1. *STRATEGISTS'S COST ANALYSIS OF SOLAR PORTFOLIOS 1 AND 2*

a. *Modeling Review*

Attachment 2: Department Estimate of Xcel's Solar Energy Standard Requirement

Docket No.: E002/M-14-162

Figure 1: Solar Portfolio 1 Minus Base Case

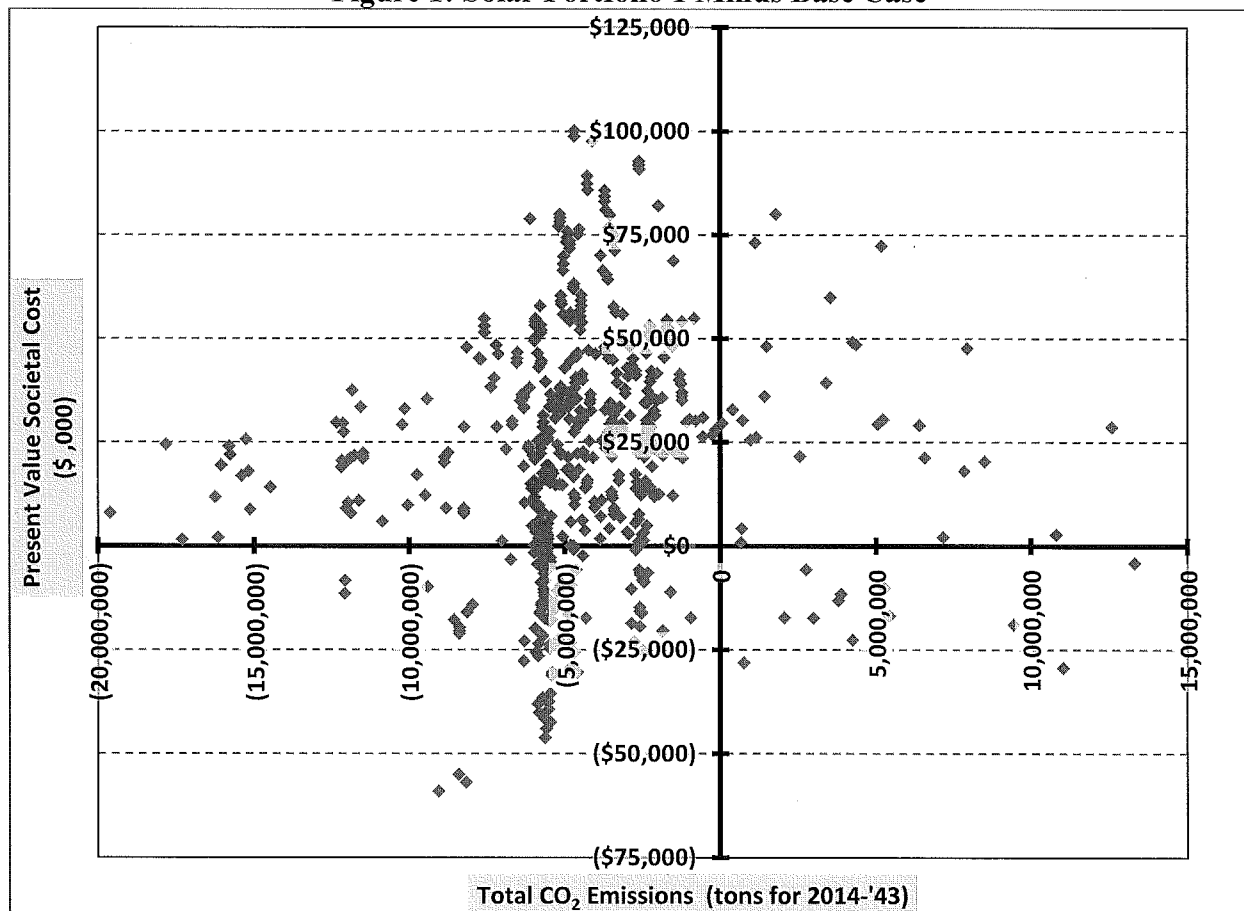
The impact of adding Solar Portfolio 1 to the base case is shown in Figure 1 below. Figure 1 shows that Solar Portfolio 1 generally increases system costs but reduces overall CO₂ emissions. In terms of energy production, for every MWh from coal that the Solar Portfolio 1 displaced, on

average, about 4.5 MWh of natural gas were displaced. The cost impacts range from an increase of \$100.2 million present value of societal costs (PVSC) measured over 30 years, 2014 to 2043 to a decrease of \$59.1 million PVSC with the average impact being a cost increase \$28.8 million PVSC. The impact on CO₂ emissions ranges from an increase of 13.3 million tons (again over 30 years, 2014 to 2043) to a decrease of 19.6 million tons with the average impact being a decrease of 4.6 million tons.

Figure 2: Solar Portfolio 2 Minus Base Case

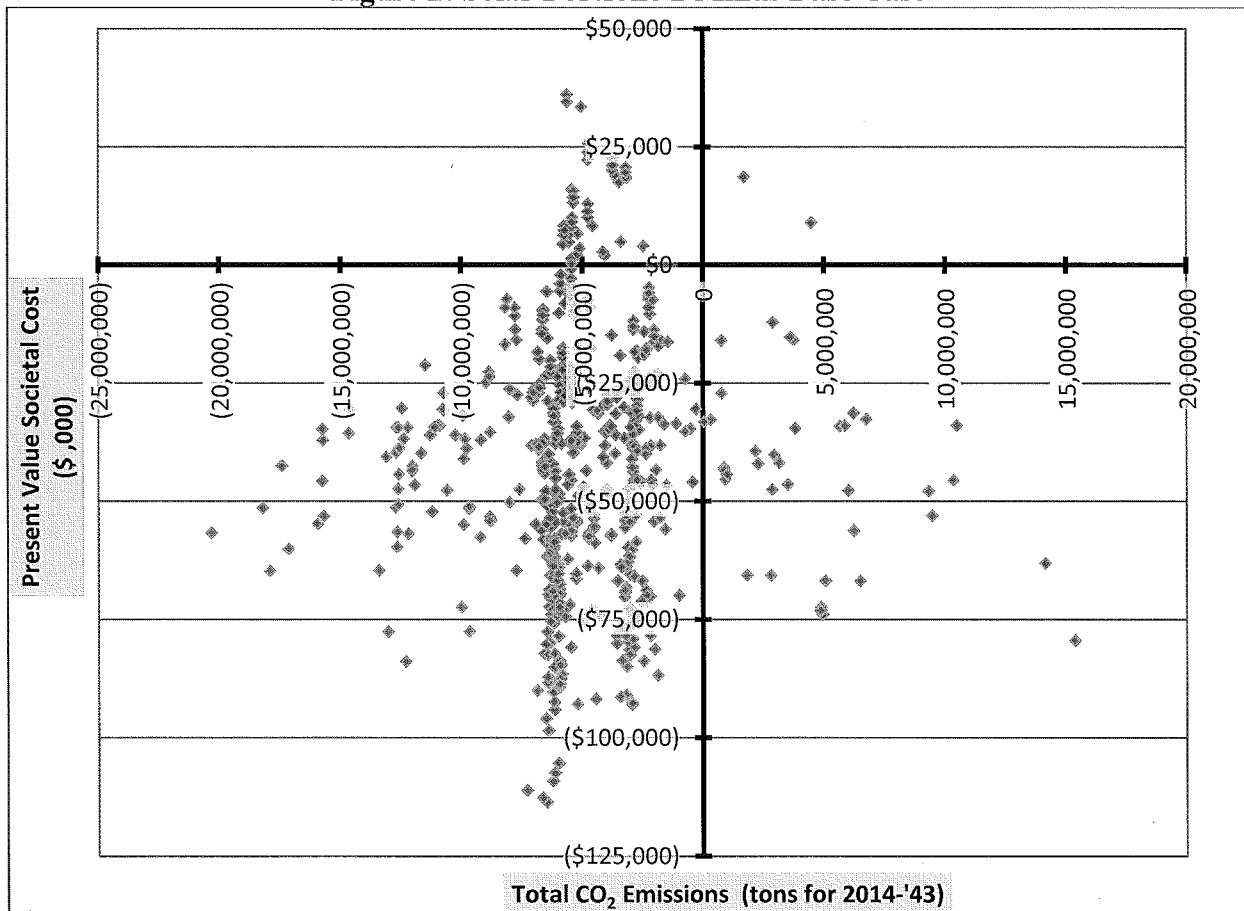
The impact of adding Solar Portfolio 2 to the base case is shown in Figure 2 below. Figure 2 shows that Solar Portfolio 2 generally decreases system costs and overall CO₂ emissions. In

terms of energy production, for every MWh from coal that the Solar Portfolio 2 displaced, on average, about 4.8 MWh of natural gas were displaced. The cost impacts range from an increase of \$36.0 PVSC to a decrease of \$113.7 million PVSC with the average impact being a cost decrease \$34.9 million PVSC.⁵ The impact on CO₂ emissions ranges from an increase of 15.4 million tons to a decrease of 20.3 million tons with the average impact being a decrease of 5.0 million tons.

Figure 3: Solar Portfolio 2 Minus Solar Portfolio 1

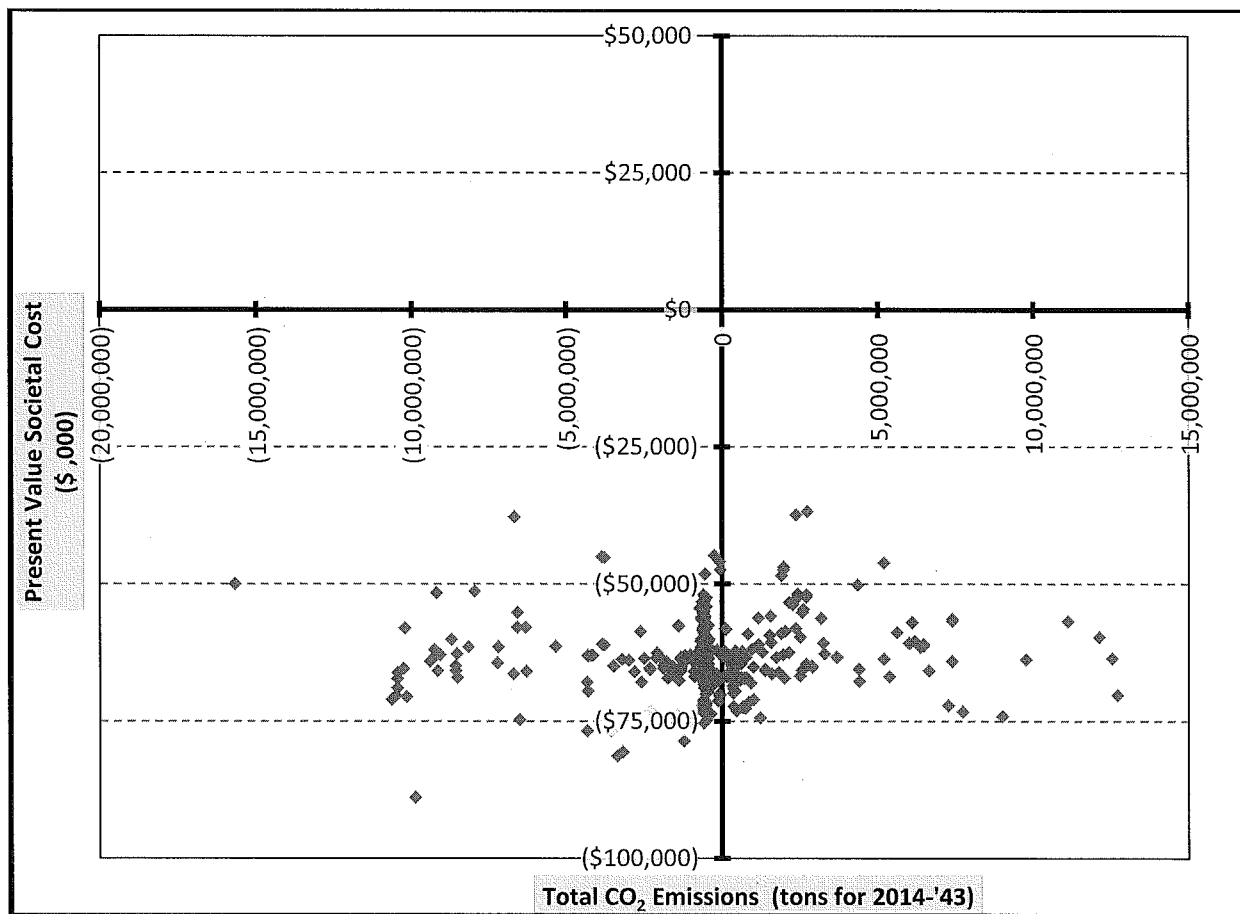
The difference between adding Solar Portfolio 1 and Solar Portfolio 2 to the base case is shown in Figure 3 below. Figure 3 shows that Solar Portfolio 2 decreases system costs relative to Solar Portfolio 1 and Solar Portfolio 2 has similar system CO₂ emissions when compared to Solar Portfolio 1. The difference in cost impacts for any one contingency range from a decrease of \$36.8 PVSC (Solar Portfolio 2 is cheaper than Solar Portfolio 1) to a decrease of \$88.9 million PVSC with the average impact being a cost decrease \$63.6 million PVSC. The impact on CO₂ emissions ranges from an increase of 12.7 million tons to a decrease of 15.7 million tons with the average impact being a decrease of 0.4 million tons.

In summary, Solar Portfolio 2 has a significantly lower PVSC than Solar Portfolio 1 and Solar Portfolio 2 results in similar system CO₂ emissions when compared to Solar Portfolio 1.
